ATP Channel 7

State Significant
Development
Modification
Assessment
(MP 06 0149 MOD 3)

February 2020

Figure 3 | Photomontage, view from Central Avenue (source: Applicant's Modification report)

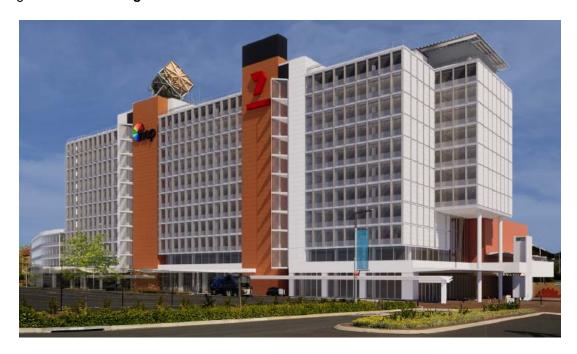
- the external colour for the northern sections of the building should be revised to be more respectful to the aged brick colour of the Locomotive Workshop
- the need to ensure the proposed new cladding material does not present a flammability risk
- the glazing should retain the same transparency as the existing glazing.

Council raised concern with the initially proposed 'orange' colour of the aluminium panels and suggested that a more subdued colour would be more appropriate in the context of the Locomotive Workshop. In response to Council's concerns, the Applicant proposes a terracotta colour (**Figure 3** and **4**).

The Department has considered the proposed change in colours, materials and finishes and supports the proposal as it:

- compliments Building 1 and 2 which have recently been constructed within the Australian
 Technology Park (Figure 5)
- is subtle and sympathetic to the brick colour of the adjoining Locomotive Workshop (Figure 6)
- simplifies and modernises the appearance of the Channel 7 building without significantly altering the appearance of the development
- continues to achieve a high-quality appearance consistent with the Design Excellence provisions of State Environmental Planning Policy (State Significant Precincts) 2005.
